UNITED STATES
NUCLEAR REGULATORY COMMISSION
WASHINGTON, D. C. 20555

SUBJECT: WESTINGHOUSE REORGANIZATIONS

In your letters of February 15 and July 15, 1980, you notified us of organizational changes within the Westinghouse Water Reactor Divisions and within the Product Assurance Department of the Westinghouse Nuclear Technology Division. You provided several marked-up pages from Revision 9A of WCAP 8370 which described in some detail the organizational changes.

FIGURE 17.3. NUCLEAR TECHNOLOGY DIVISION QUALITY ASSURANCE PROGRAM ORGANIZATION

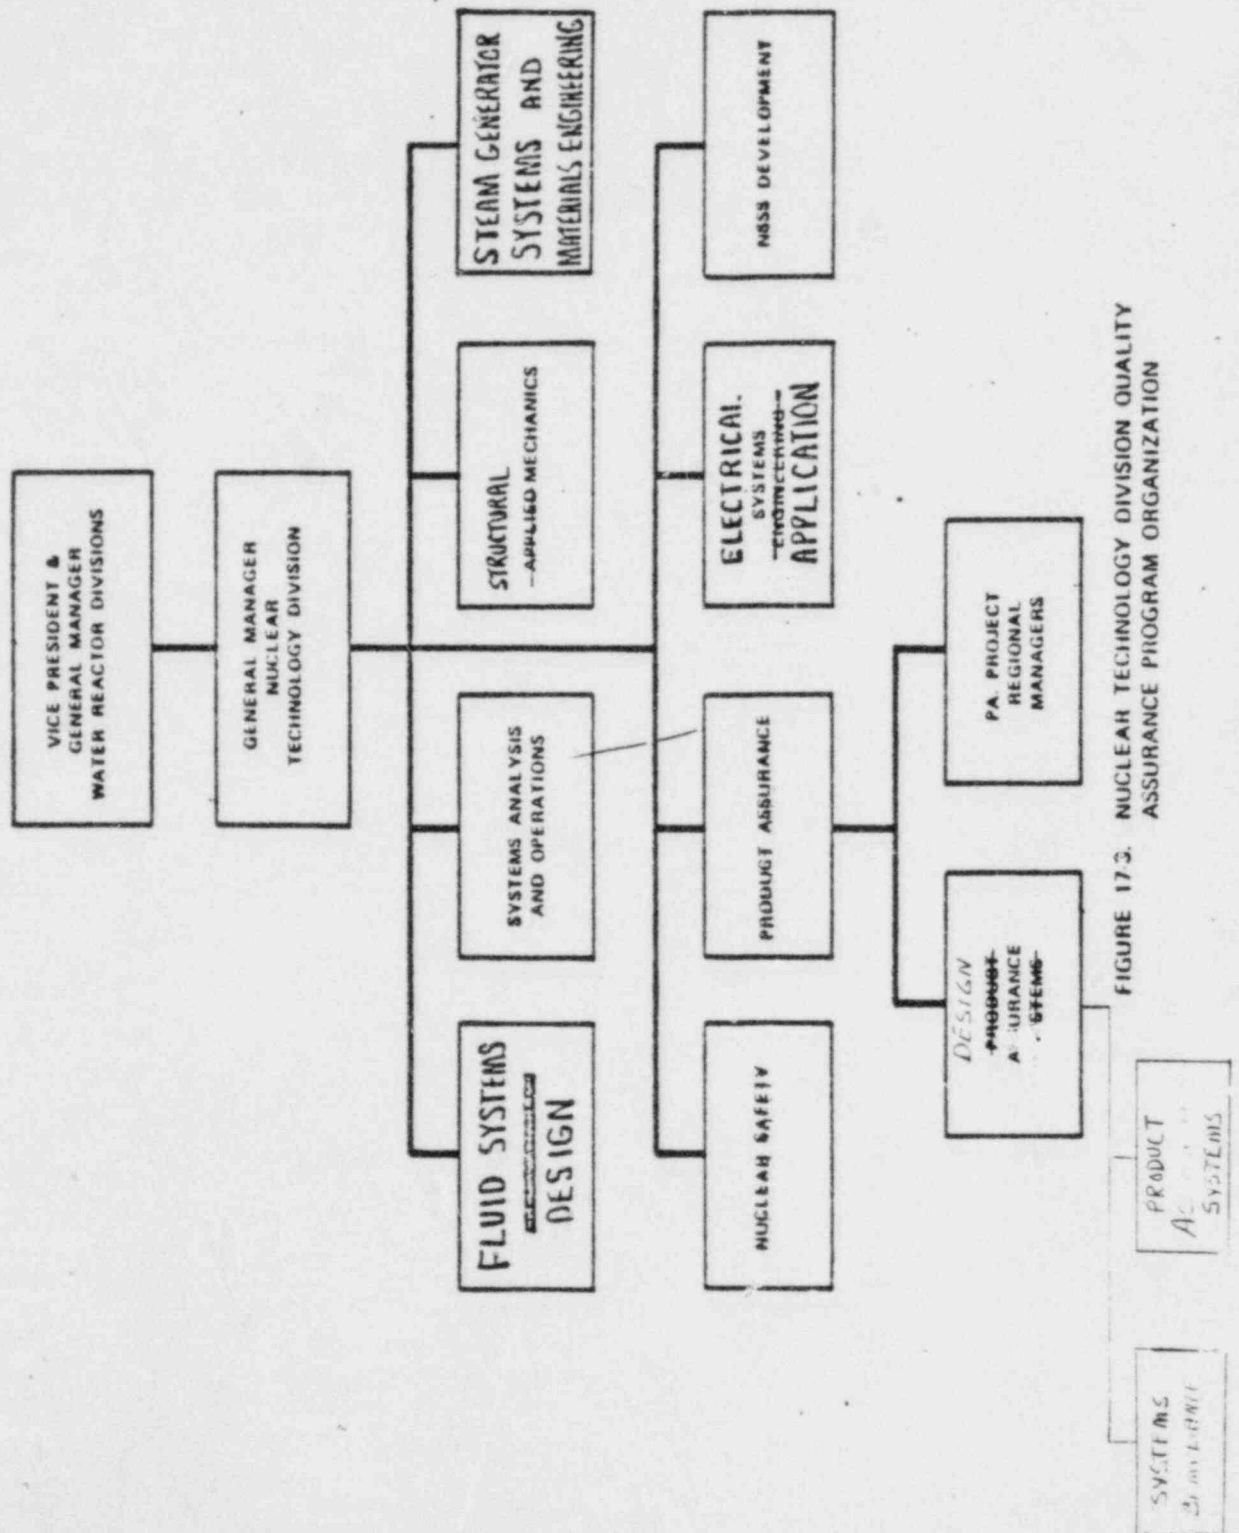
2-15-80 F
7-15-80 letters from [unclear]
